HARRIS TRAIL ROAD AND TIMBER TRAIL ROAD SIGNAL

T&H PROJECT NO.
J-27691.0122

ADDENDUM NO. 1

June 22, 2026

DRAWING No. **01-0001**

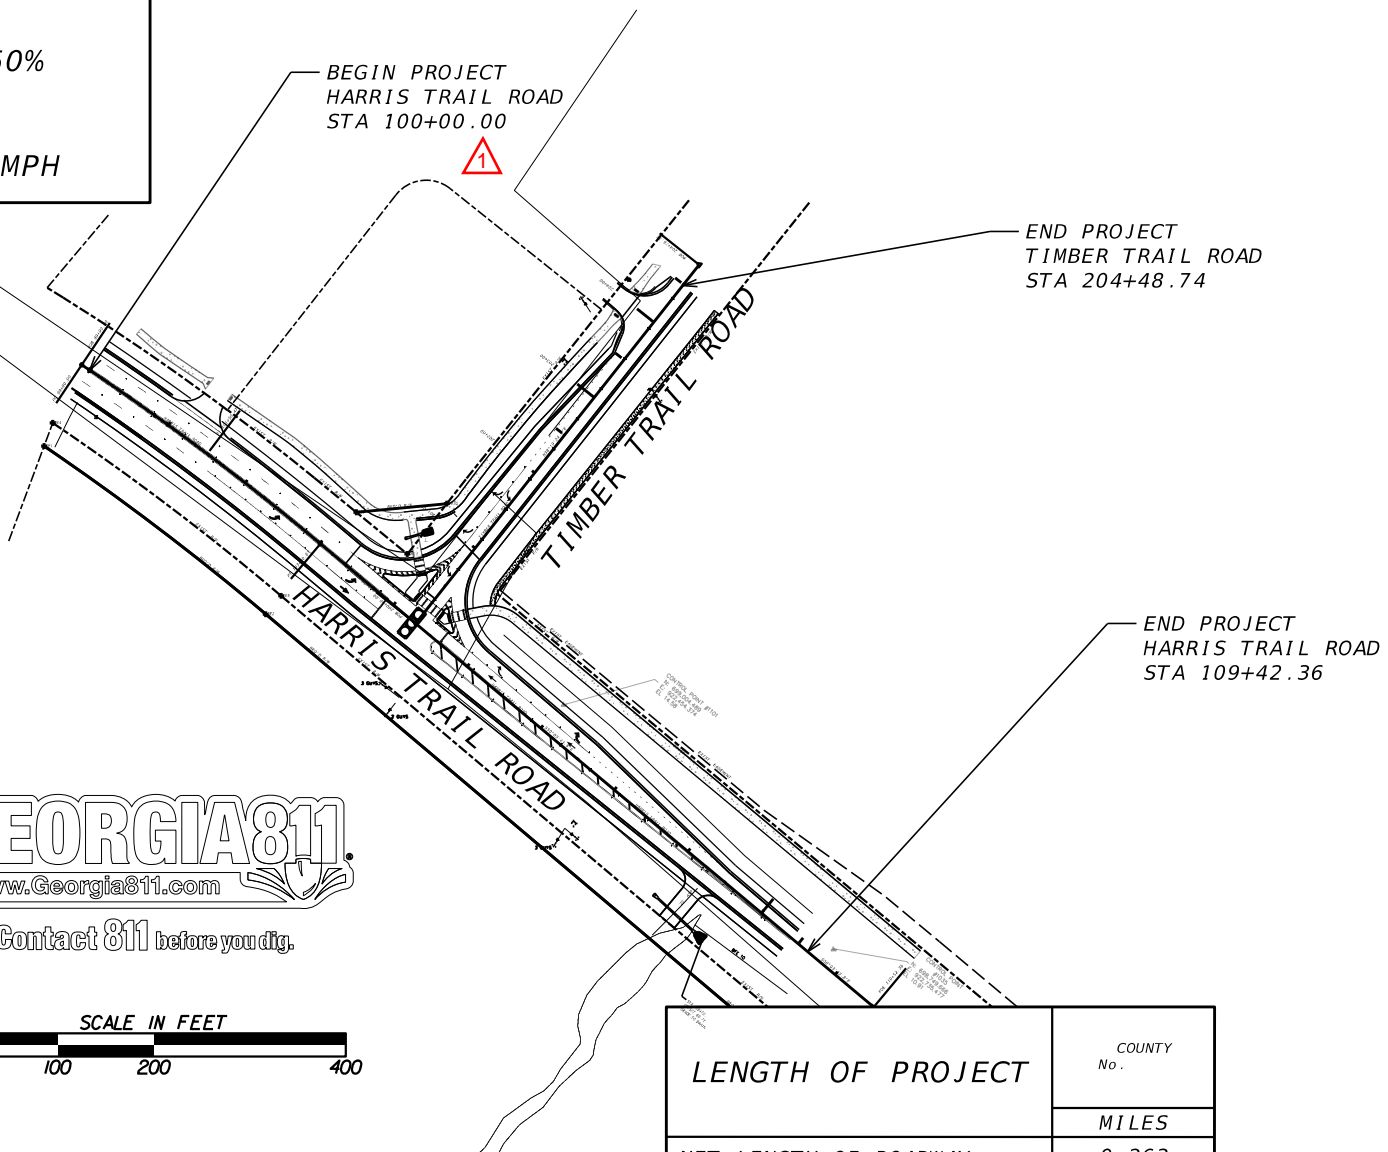
- 1 Series – Revised Begin Construction Limits to whole station number.
- 4 Series - Lane closure times updated, Asphalt Drive pavement section note added, GA Std. 1401 added
- 13 Series – Median sidewalk dimensions added, sidewalk pipe crossing (pipe size) clarified, additional clarifying annotations.
- 26 Series – Additional Type 2 Arrows for turn lanes added
- 27 Series – Mast arm quantities updated (clarified)
- 50 Series - Revised begin construction limits
- 51 Series – Disturbed Areas and Silt Fence quantities updated
- 54 Series – Limit of Disturbance and Silt Fence lines updated, Construction Exit/Washout moved. Annotations Added

CHECKED:	DATE:	DRAWING No.
BACKCHECKED:	DATE:	13-0002
CORRECTED:	DATE:	
VERIFIED:	DATE:

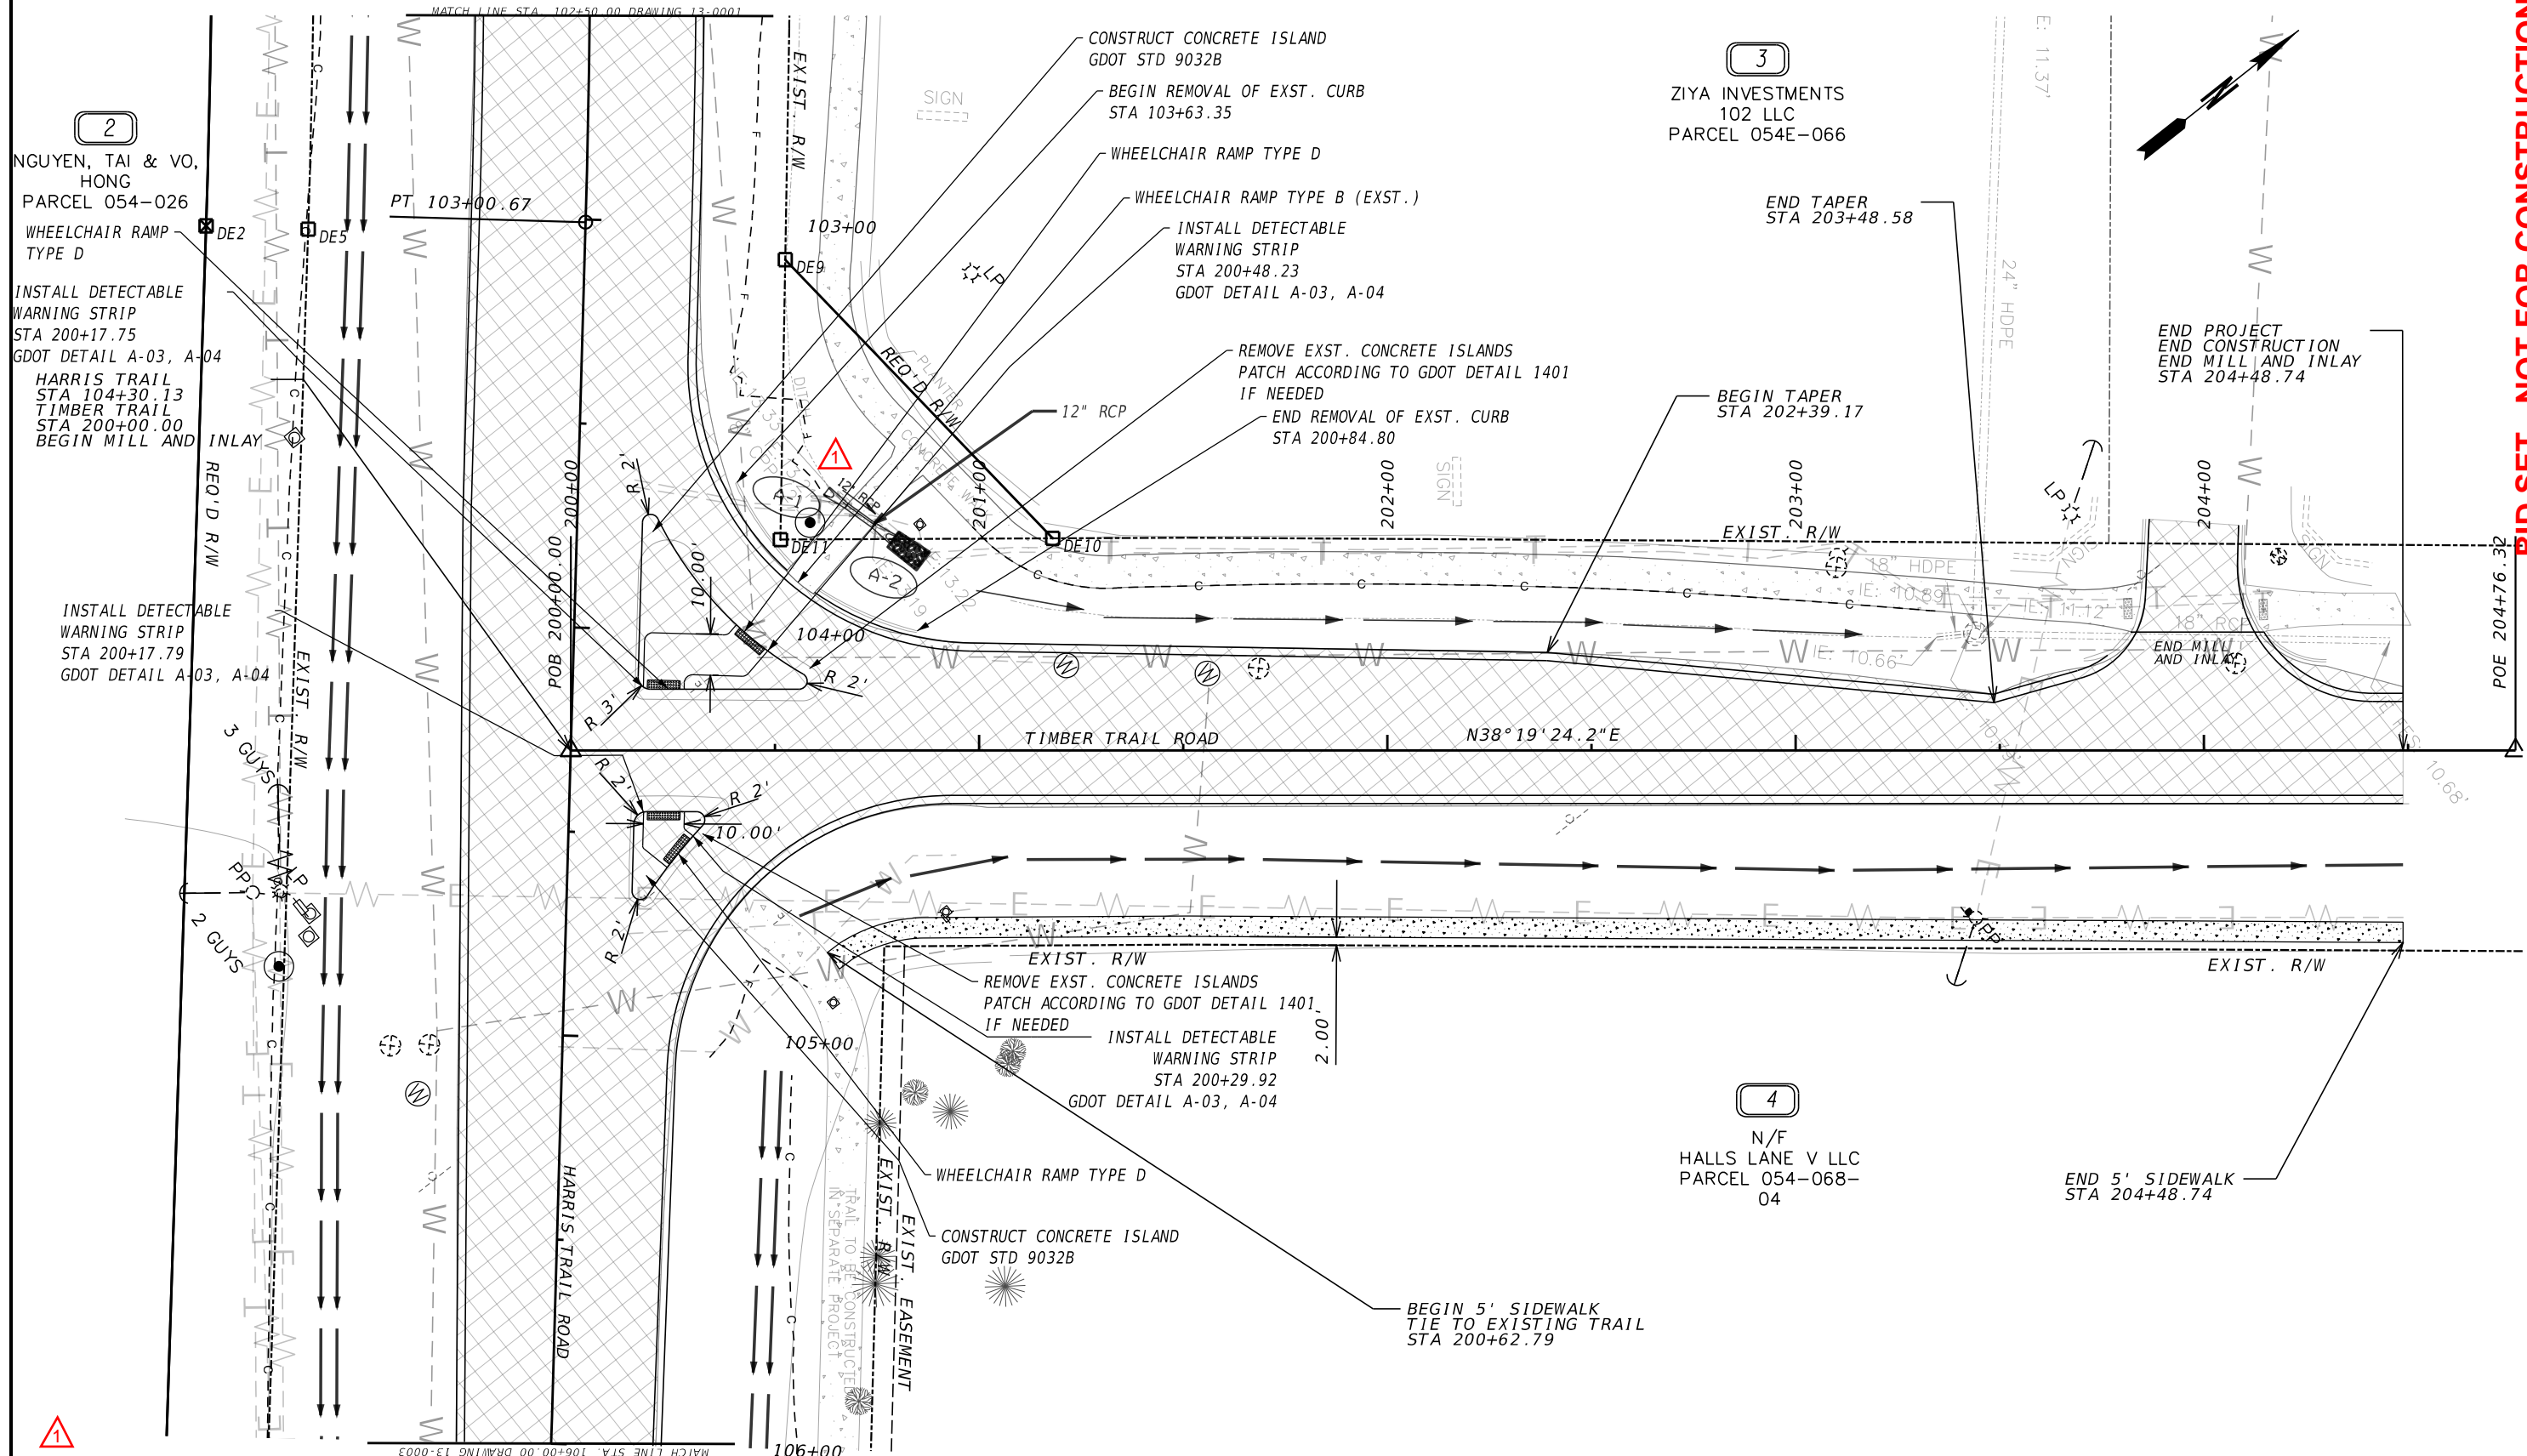
Answer: Yes, this item has been broken into 2 separate items which can be seen on Page 27-0004 the Pay Items Table, and in the bid form.
2. Question: Plan sheet 13-002 shows 8' of 12"x18" RCEP, but the bid item is for 12" RCP Class III. Which is correct?

Answer: Please refer to the Class "B" Concrete Base for Widening Detail on Page 05-0001. Assume a 6" maximum depth.
6. Question: Note #3 on plan sheet 05-0002 says "Existing pavement under median areas and new full depth pavement shall be removed." If we demo all of the pavement under the existing triangle islands to be replaced, what do we fill the holes in with to bring the bottom of the new 6" medians up to grade?

Answer: Plan sheet 13-0002 has been updated to show 12" RCP.
3. Question: What is the paving section for the one 20' wide asphalt driveway on sheet 13-0003? Should this include any base stone?

Answer: Refer to plan sheet 13-0002 for an updated median annotation to clarify. A patching item (402-1802) has been added to the bid form.
